PRS Hollowbody Piezo Electronics Diagram

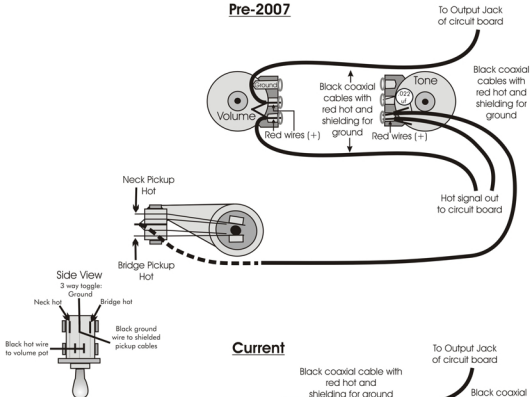
Pre-2007

Current

Note: Shielded Jack Cable is soldered to ground of 3-way toggle. Shielded cables of pickup harness wires are soldered to jack cable. Black ground wire is soldered to shielding of pickup harness. Solder bridge ground wire to any shielded cable of pickup harness.
